## **STANDARD FIELD SERVICE BULLETIN**

FSB Number	CHRAEFSB2016-12 Rev. 1
Author	Tony Bryan
Date	08/30/2016
Subject	XT1585 Droid Turbo 2, XT1580 Moto X Force - Does Not Charge - USB Connection Issues
Model Affected	XT1585 Droid Turbo 2, XT1580 Moto X Force
Level Of Repairs	Level 3

**Fig. 1 - VR502 Diode Location**

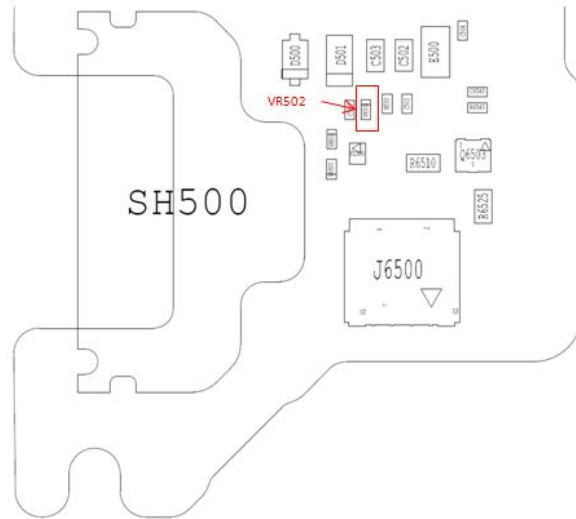
- Overvoltage Protection Diode VR502 (P/N: 48014187001) Damaged. Component is damaged from an undetermined over-voltage condition creating a low resistance on Pin #4 (EMU\_ID) of the uUSB Connector. See Fig. 1 below.

- Overvoltage Protection Diode Damaged - Motorola added new factory test procedures to screen for this issue - Completed February 22, 2016.
- uUSB Connector Damaged - Motorola added epoxy (Loctite EO1072) over the internal pins of the uUSB Connector to help strengthen the mechanical connection to the PCBA - Completed April 25, 2016

**Fig. 2a - External Contact Damage**

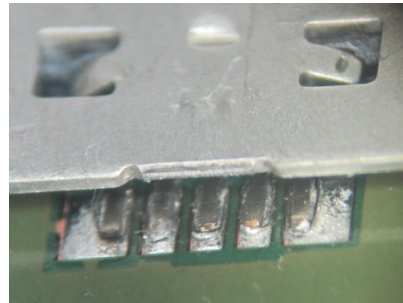
- uUSB Connector J500 (P/N: 09014162015W) Damaged. Connector has either damaged external contacts (Fig. 2a) or cracked solder joints on internal pins (Fig. 2b). The damage is due to excess mechanical force applied to connector from improper insertion/handling. See images below.

**Fig. 3 - PCBA w/Pad Delamination**

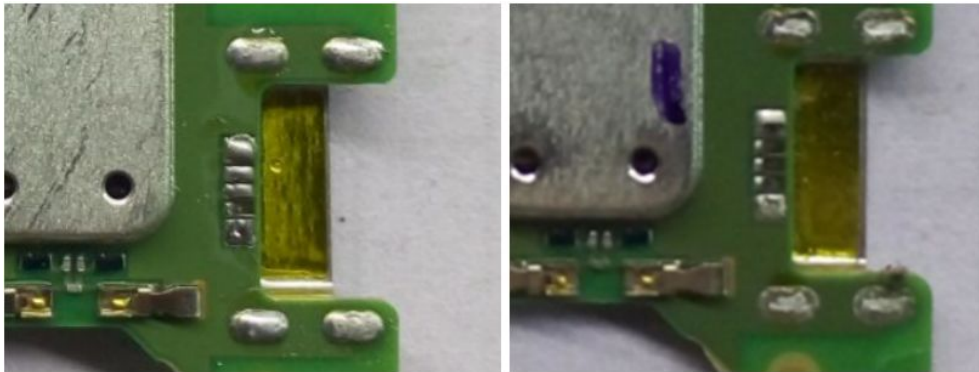
1. Carefully inspect the uUSB Connector J500, under 2x Magnification, for any signs broken/cracked solder joints.
  - a. If broken/cracked solder joints are observed, then continue to Step 2.
  - b. If no broken/cracked solder joints are observed, then skip to Step 4.
2. Remove uUSB Connector J500 from PCBA using approved procedure and then carefully inspect PCBA for any sign of pad delamination. See Fig. 3 below for examples of pad delamination.

- a. If any sign of pad delamination is observed (like shown in Fig. 3 above), then the PCBA **must** be scrapped.
  - b. If no pad delamination is observed, then continue to Step 3.
3. Place new uUSB Connector J500 using approved procedure, clean area to remove any excess flux, and carefully inspect each pin under 2x Magnification for proper solder joint.
4. Apply the Epoxy (Loctite EO1072) , carefully follow the **L3\_USB Epoxy Application Procedure** which is available to download from the [Global Service Site](#).
5. Continue with normal Repair Process.

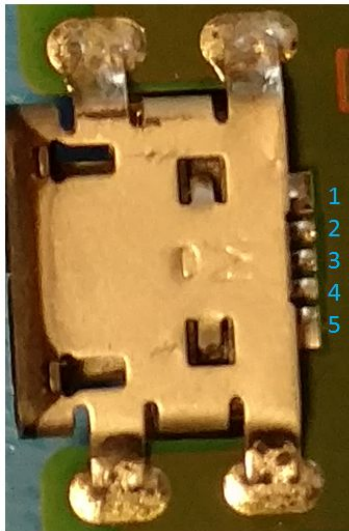
1. Confirm the customer complaint by testing “Charging” functionality using approved testing procedures.
2. Use a Digital Multimeter (DMM) to measure resistance from each of uUSB Connector pins to GND. See image below for details.
  - a. If one or more pins measure a higher than normal resistance, then uUSB Connector J500 needs replaced. Follow the Rework Procedure detailed in **Field Service Action - A** above.
  - b. If Pin #4 (EMU\_ID) of the uUSB Connector measures a lower than normal resistance, then replace Overvoltage Protection Diode VR502 (P/N: 48014187001).

- c. If Pins #2, #3 (USB D+/D-) of the uUSB connector measure a low resistance short to GND, then replace the U1000 MSM8994 IC (Service P/N: 51016314001).
3. Apply the Epoxy (Loctite EO1072) to the uUSB Connector. Carefully follow the **L3\_USB Epoxy Application Procedure** which is available to download from the [Global Service Site](#).
4. Per Service Manual, carefully reassemble the device and completely retest the device, per standard Service procedure, to ensure proper repair.

Pin	Line	Nominal Resistance	Symptom (If Bad)
1	USB_VBUS	30-35k Ohm	No Charge Indication / No SOL
2	USB_D-	725-755k Ohm	No Turbo Charge
3	USB_D+	725-755k Ohm	No Turbo Charge
4	EMU_ID	150-300k Ohm	Does Not Charge or Power-Cycles
5	GND	0 Ohm
